Art Unit: 3746

**DETAILED ACTION****Status of Claims**

3. **Claims 1-8** are rejected under 35 U.S.C. 102(b) as being anticipated by United States Patent No. 5,800,147 to Arai et al. directed to a Swash Plate Compressor.

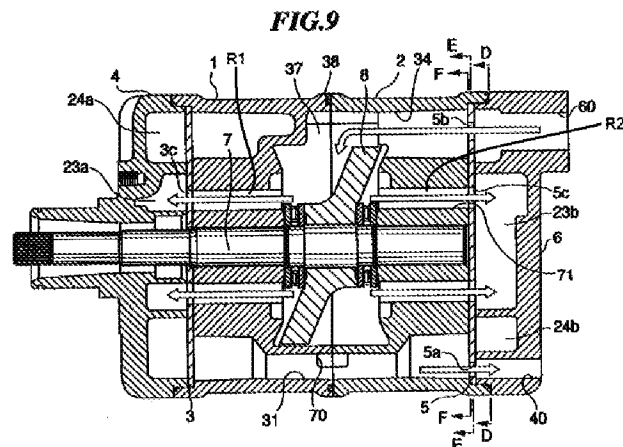
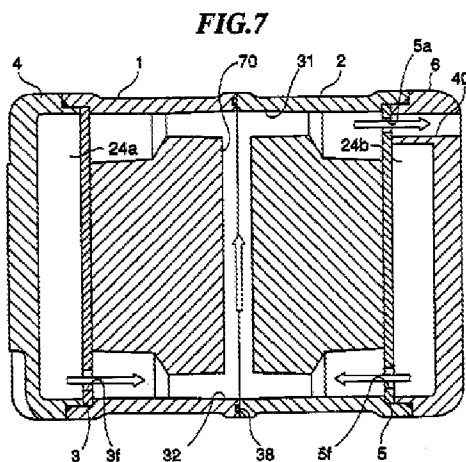
In regards to Independent **Claim 1**, and with particular reference to Figures 7 & 9 shown immediately above, Arai et al. discloses:

A swash plate compressor, comprising: a housing having formed therein cylinders (1, 2); a drive shaft (7) rotatably supported at said housing; a swash plate (8) that is housed inside a swash plate chamber (37) formed at said housing and rotates as one with said drive shaft (7); and pistons (12) that slide reciprocally inside the cylinder bore (1, 2) as said swash plate (8) rotates, wherein a front-side intake chamber (23a) and a rear-side intake chamber (23b) disposed to the front and to the rear of said swash plate chamber (37) along the axial direction, in which a working fluid to be guided into said cylinders (1, 2) is stored, a front-side outlet chamber (24a) and a rear-side outlet chamber (24b) disposed to the front and to the rear of said swash plate chamber (37) along the axial direction, in which the working fluid having been compressed by said pistons (12) is stored, a first gas passage (34) and a second gas passage (33) extending along the axial direction, a third gas passage (31) formed substantially symmetrical to said first gas passage relative to a plane containing said drive shaft (7), a fourth gas passage (32) formed substantially symmetrical to said second gas passage (31) relative to the plane containing said drive shaft (7) and communicating with said second gas passage (33) and an external component (an evaporator, not shown) that includes an intake port and an outlet port to be connected to piping, are all disposed at said housing; wherein either said first gas passage (34) or said third gas passage (31) is made to communicate with said

intake port (60) to supply the working fluid into said front-side intake chamber (23a) and said rear-side intake chamber (23b); and wherein either said second gas passage (33) or said fourth gas passage (32) is made to communicate with said front-side outlet chamber (24a) and said rear-side outlet chamber (24b) and said second gas passage (33) or said fourth gas passage (32), which is not in communication with said outlet chambers, is made to communicate with said outlet port (40).

As shown in the Figures above, Arai et al. discloses a swash plate compressor for the compressing of a refrigerant gas in a refrigerant circuit. The compressor contains front- and rear-side inlet chambers, as well as front- and rear-side discharge chambers, for storing refrigerant gas in its un-compressed and compressed states, respectively. To begin, Arai et al. first describes the basic compressor structure by stating "The swash plate compressor includes cylinder blocks 1 and 2 arranged on a front side and a rear side, respectively, and front and rear heads 4 and 6 secured to a front-side end of the front-side cylinder block and a rear-side end of the rear-side cylinder block, respectively...The cylinder block 1 is formed with a through hole 50 through which a drive shaft 7 extends, five cylinder bores 11 which are arranged at predetermined circumferentially-spaced intervals around the through hole 50 and extend longitudinally in a fashion parallel with the through hole 50, three refrigerant outlet passages 31 to 33 which extend in a fashion parallel with the cylinder bores 11, and a refrigerant inlet passage 34 through which low-pressure refrigerant flows."

passages (i.e. gas passages) disclosed in Arai. In particular, Arai states "The refrigerant outlet passages 32, 33, communicate with discharge chambers 24a and 24b via ports 3f and 5f formed through a valve plate 3 and a valve plate 5, respectively, and the other refrigerant outlet passage 31 communicates with a discharge port 40 via a port 5a. Further, a guide passage 70 which communicates an intermediate portion of the refrigerant outlet passage 31 with an intermediate portion of the refrigerant outlet passage 32 extends in a junction of the cylinder blocks 1 and 2." (Column 4, Lines 34-43) In Arai's compressor, passages 34 and 31 act as the refrigerant gas inlet passages, while passages 33 and 32 acts as the refrigerant gas outlet passages (i.e. a total of 4 gas passages). Hence, it can be seen that either the first or third gas passage is made to communicate with the intake port 40, while either the second or fourth gas passage is made to communicate with the outlet port 60. More specifically, Arai discloses that the discharge passage that is NOT in communication with the discharge port is in communication with the outlet chambers. In particular, Arai states "According to the invention, since the cylinder block has the guide passage therein for communicating the intermediate portion of any of the at least two refrigerant outlet passages other than the one of the at least two refrigerant outlet passages being communicated with the discharge port, with the one of the at least two refrigerant outlet passages being communicated with the discharge port, refrigerant is permitted to flow from the former, which is not communicated with the discharge port, to the latter, which is communicated with the discharge port, whereby refrigerant is prevented from becoming standing within the any of the refrigerant outlet passages other than the refrigerant outlet passage

communicated with the discharge port.” (Column 2, Line 66 – Column 3, Line 11)

Therefore, it can be seen that Arai contains Applicant’s four claimed gas passages, structured in the same way.

4. In regards to dependent **Claim 2**, it can be seen in Figure 9 that relay passages (R1 and R2) are formed with the first and third gas passages (34, 31) in order to communicate the swash plate chamber with the front- and rear intake chambers (23a, 23b). Regarding dependent **Claims 3 and 4**, and with reference to Figures 7 & 9 above, as well as Figure 11 of Arai, it can be seen that valve plates are disposed between front- and rear-side cylinder heads (4, 6) in order to control the inflow and outflow of refrigerant gas. To begin Arai states “The refrigerant outlet passages 32, 33, communicate with discharge chambers 24a and 24b via ports 3f and 5f formed through a valve plate 3 and a valve plate 5, respectively, and the other refrigerant outlet passage 31 communicates with a discharge port 40 via a port 5a.” (Column 4, Lines 34-39) Moreover, Arai discloses “The valve plate 5 is formed therethrough with the port 5a and a port 5b which communicate the refrigerant inlet passage 34 and the refrigerant outlet passage 31 in the cylinder block 2 with the suction port 60 and the discharge port 40 in the rear head 6, respectively, and ports 5c which communicate passages 71 in the cylinder block 2, which communicate with the swash plate chamber 37, with the suction chamber 23b.” (Column 5, Lines 8-15) Finally, Arai states that the valve plates utilize inlet and outlet valves by stating “During the suction stroke, suction valves 25, 26 open to permit refrigerant to flow from the suction chambers 23a, 23b into the compression

7. In regards to Applicant's argument that the channel 31 of Arai is only connected to the outlet port, and not communicated with the swash plate chamber, the Examiner must respectfully disagree. Channel 31, as can be seen in Figures 7 and 9 of the previous Office Action, is indirectly communicated with the swash plate chamber 37 through relay passages R1 and R2 and intake chambers 23a and 23b.
